# LOCA at 11th and Belmont The Goat Blocks

**Design Review Submittal** (LU# 14-125908 DZM AD) (DAR# 13-224797) (Pre-Application# EA-203772)

PRESENTED BY: KILLIAN PACIFIC
OWNER: BELMONT INVESTMENT, LLC
ARCHITECT: ANKROM MOISAN ARCHITECTS
08.12.2014

#### **Design Updates & Comment Responses**

### **East Building**

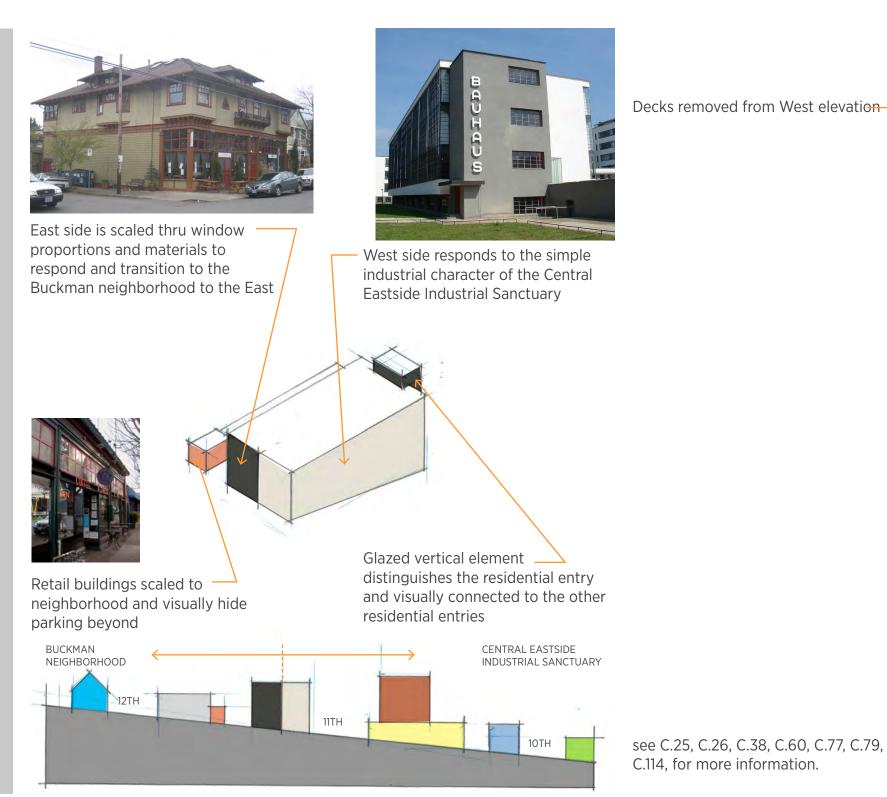
- 1. Decks
  - remove or add more
- 2. Parking behind building needs to be covered

Decks removed from West elevation

Yamhill Plaza Overlook - After DR Input

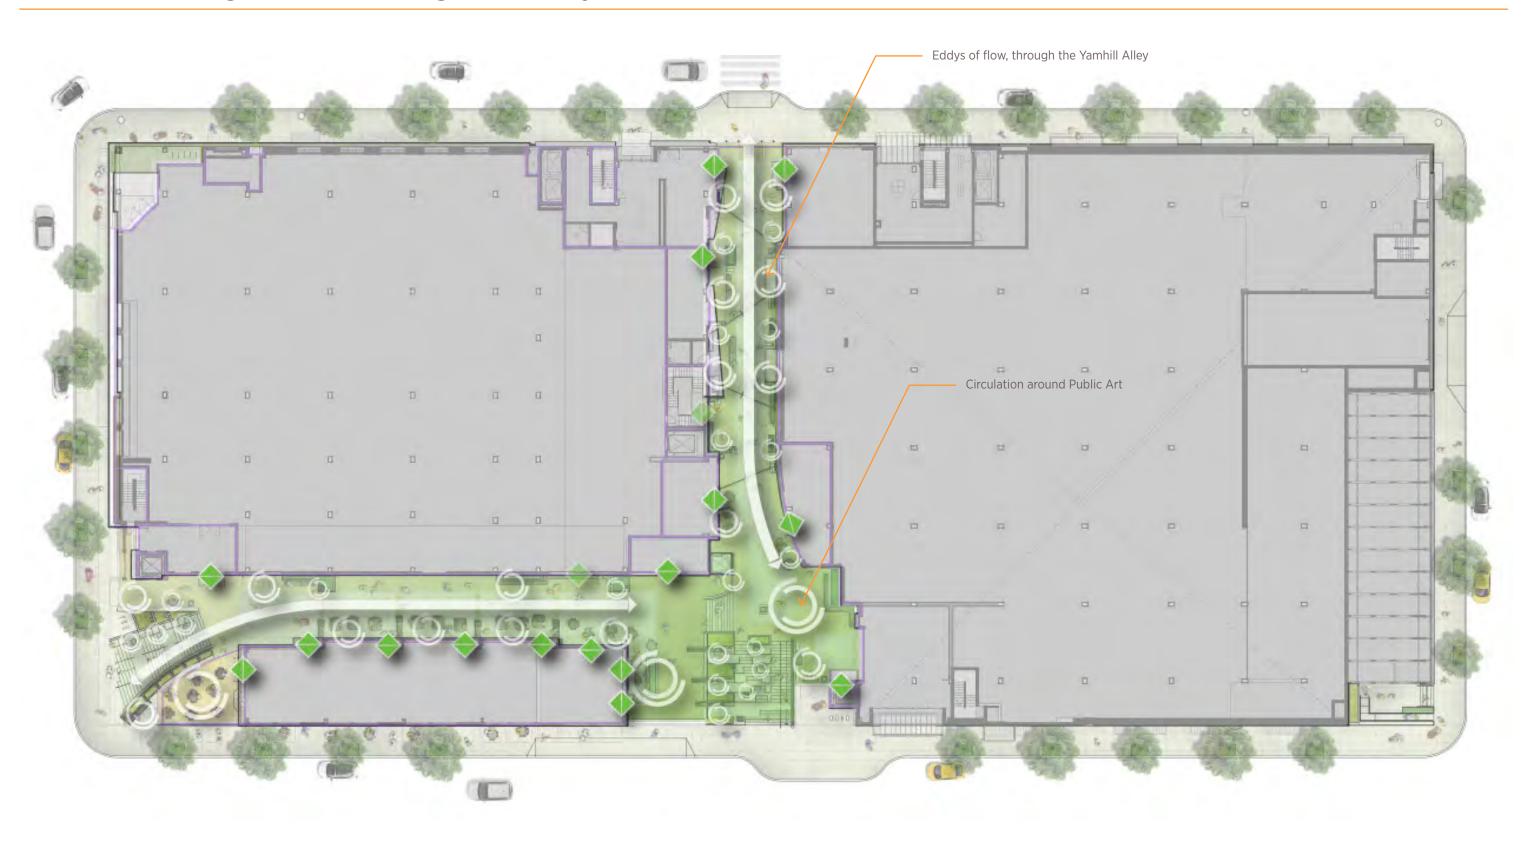
North Building West Elevation before (C.61)

### Retail Building East Elevation before (C.81)

see C.15, C.17, C.19, C.27, C.30, C.61, C.81, C.96, C.99, C.119, for more information.

## **East Building**

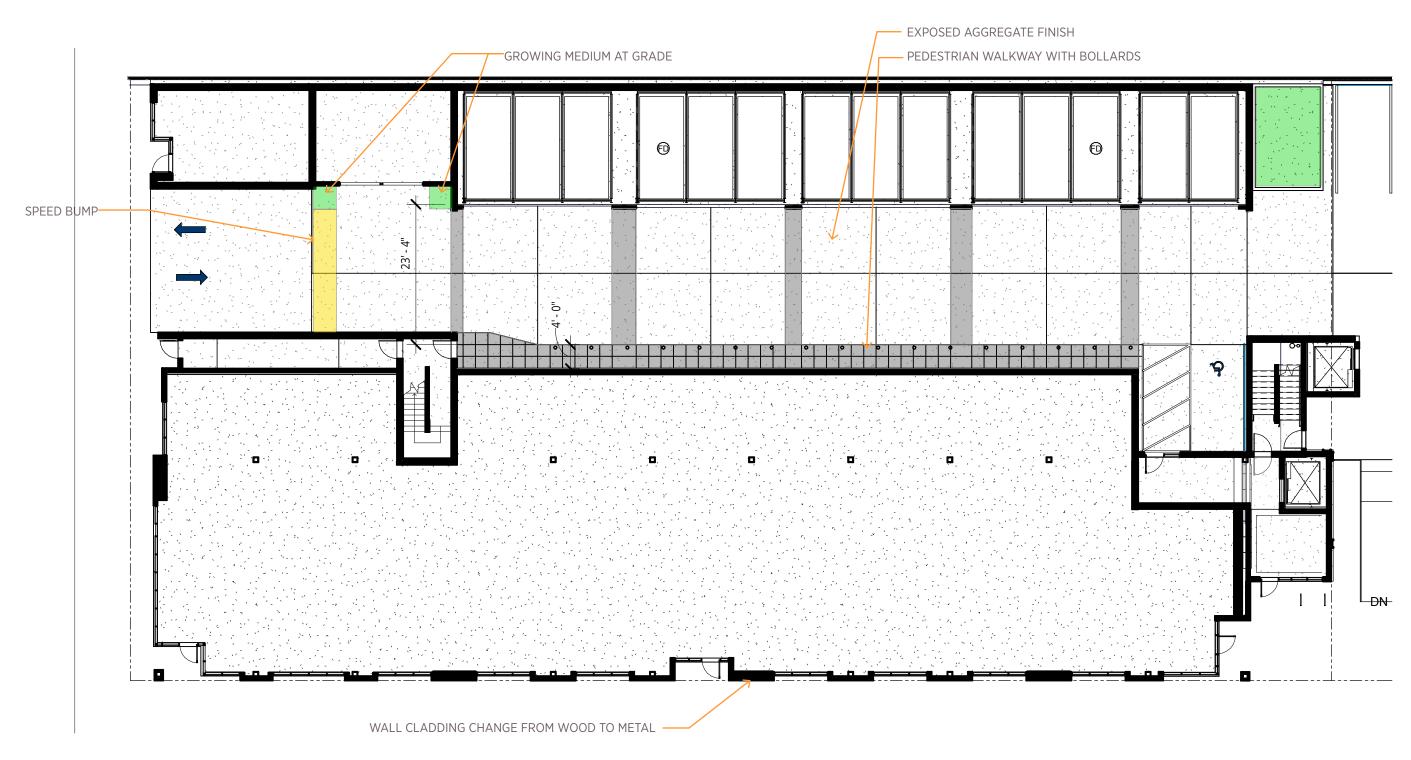
#### **DESIGN REVIEW REQUIREMENT:** B2. Protect the Pedestrian

Protect the pedestrian environment from bicycle and vehicular movement. Develop integrated identification sign and sidewalk oriented night lighting system that offers safety, interest and diversity to the pedestrian. Incorporate building equipment, mechanical exhaust routing systems and /or service areas in a manner that does not detract from the pedestrian environment.

**RESPONSE:** The sidewalks are lit via street lights. There are canopies at all retail frontages including the micro retail on Belmont. A speed control bump has been incorporated at the Belmont entry ramp to slow vehicles down prior to engaging the residential parking zone. A Similar speed control device will be installed at the IG zone parking additionally 5 MPH-SLOW signage will be incorporated. The residential parking area is covered with a trellis structure and the floor surface finish changes from smooth broom finish to exposed aggregate. The overhead trellis and the concrete finish change will all contribute to slowing cars down in this area. The residential parking has a defined accessible parking space that connects directly to the building lobby. A pedestrian zone has been indicated with bollard protection that connects to either building entry point.
